HISTORIC AND DESIGN REVIEW COMMISSION

HDRC CASE NO: 2016-056
ADDRESS: 112 E PECAN ST
LEGAL DESCRIPTION: NCB: 139 LOT: 15 NATIONAL BANK SUB UNIT-2
ZONING: D RIO-3
CITY COUNCIL DIST.: 1
APPLICANT: Irby Hightower/Alamo Architects
OWNER: Mona Ghawi/Weston Properties, LC
TYPE OF WORK: Signage
REQUEST:

DATE: 2/9/2016 HDRC Case# 2016-056

WESTON EXTERIOR SIGNAGE
DOWNTOWN, SAN ANTONIO, TEXAS
JANUARY 29TH, 2016

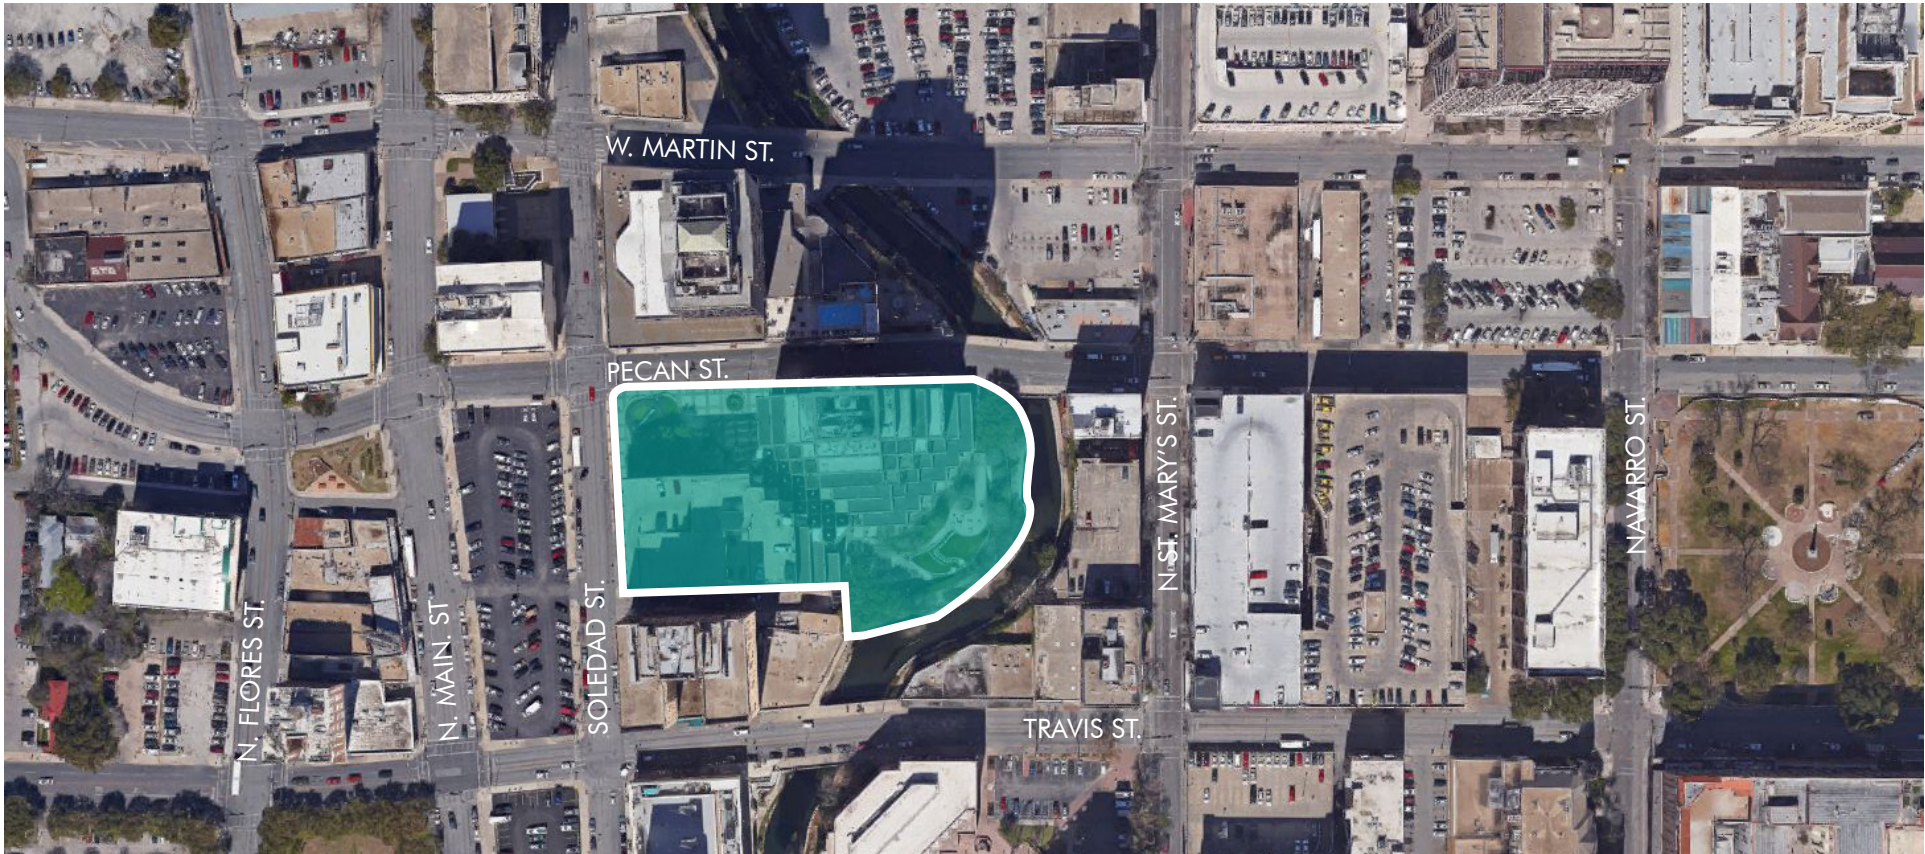
COMMENTS/CONCERNS: MG: WILL BE DIFFICULT TO SEE THE ACTUAL
SIGNAGE FROM THE RIVERWALL, HOWEVER, LIGHTING GLOW WILL
BE VIEWABLE. QUESTIONS REGARDING MATERIALS- GLASS IS BEST,
ML: POTENTIALLY VIEWABLE FROM TURN IN RIVER AT AUGUSTA,
ARCHITECTURE IS CALLING FOR A "SLOTTED" LAP- NOT AN ABRUPT
TRANSITION AS PROPOSED, BUT AN INTEGRATED ONE. MG: EXPLORE
ADDITIONAL LAPS. DOES LAP NEED TO EXTRUDE? POTENTIALLY
DECEASED. LAP NEEDS TO BE PROPORTIONATE - ADDITIONAL HEIGHT MAY
BE APPROPRIATE.

STUDY Proportions on SLENDER ELEVATION
+ Engagement of 2 FLOORS BELOW crown
[Signature] Committee Chair Signature (or representative) 11/18/15 Date

ELEVATIONS - PROPOSED (N.T.S.)

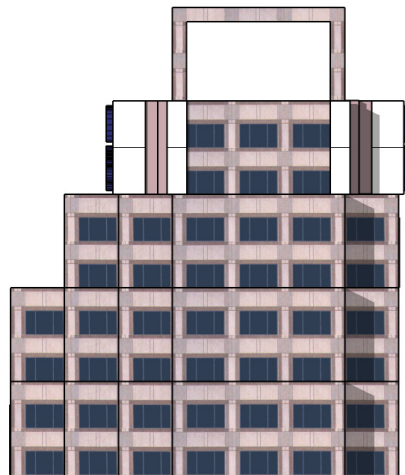
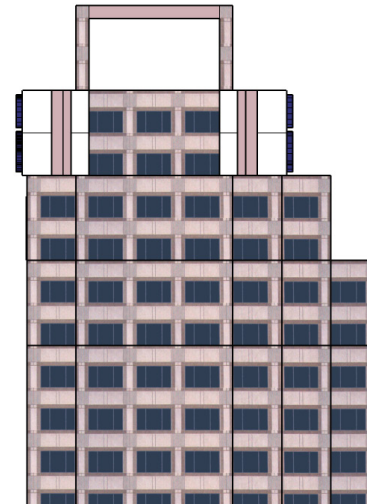
- g. At the capital of the building, the applicant has proposed to install a white flex panel system to be internally illuminated by blue LED lights which are to be powered remotely behind the wall of the structure. Incorporated into this system will be aluminum channel letters facing north and south containing a white polycarbonate face overlayed with perforated day/night vinyl to allow for the transition of lighting color. Both signs will be approximately 53' – 0" in length and 26' – 0" in height. Given the existing height and contemporary architectural style of the Weston Centre, staff finds this proposal for appropriate.

- i. Staff finds that the proposed signage will be both viewable from the public right of way at the Riverwalk adjacent to the property at 112 E Pecan as well as from the public right of way on the Riverwalk immediately north of the E Houston Street bridge. The proposal to mount this signage at the rooftop level is not consistent with the UDC Section 35-681(c)(3), however, staff finds that the applicant has designed the proposed signage in a way that is architecturally unobtrusive the massing of the existing structure and that the proposed signage will be far enough removed from the Riverwalk level that it will not negatively impact the pedestrian experience.

Staff recommends approval based on findings a through i with the stipulation that the applicant provide additional information regarding lighting intensity.
